DEVELOPMENT REVIEW COMMITTEE (DRC) COMMENT REPORT

PROJECT NAME: Taco Bell Restaurant

CASE NUMBER: UDP-S23059

REQUEST: Site Plan Level II Review: New 1,620 Square-Feet of Drive Thru Restaurant Use and Existing 15,935 Square-Feet of Commercial Use with Associated Parking Reduction

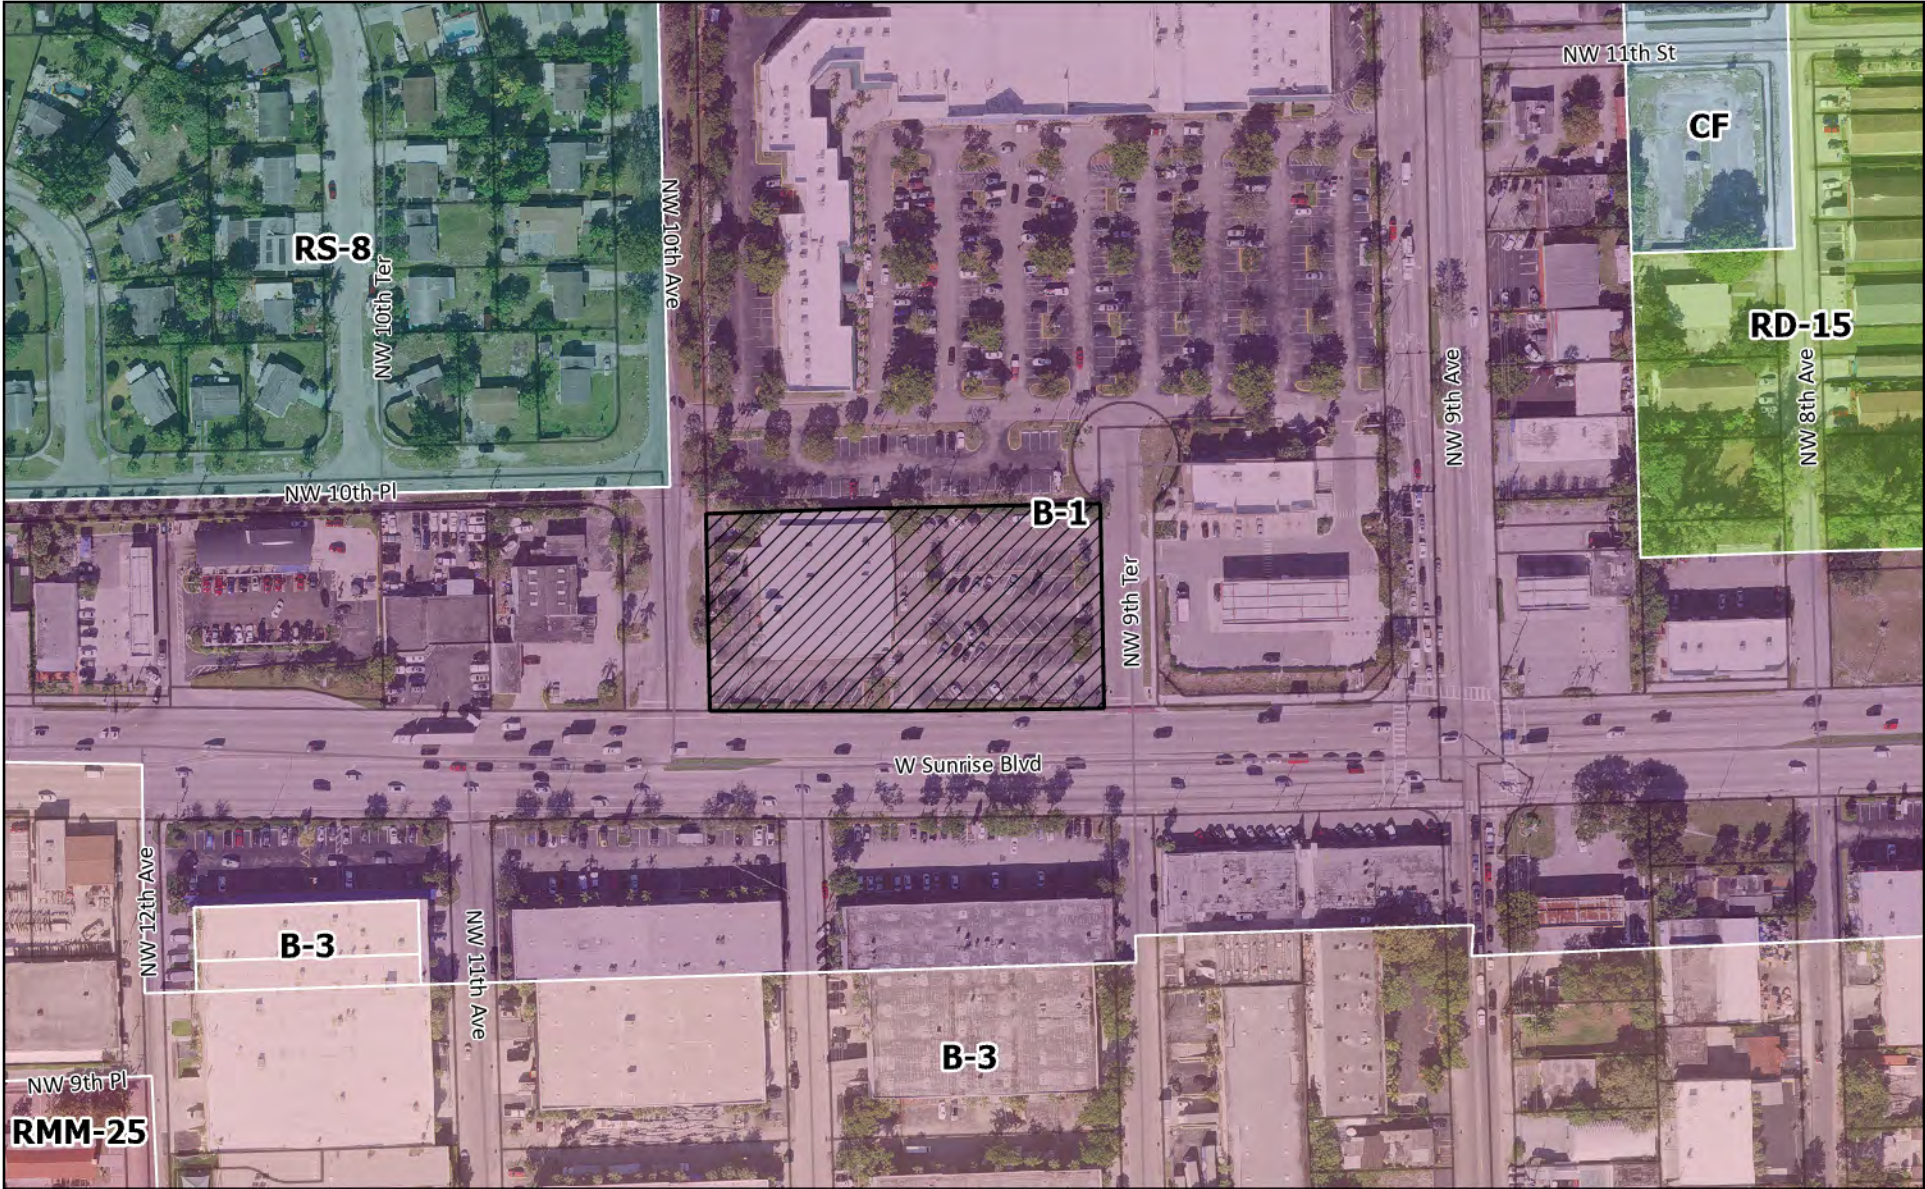
- 8) Other states have similar business models, with prototypes such as these found below. Incorporate design elements from the following images and renderings into the proposed design.
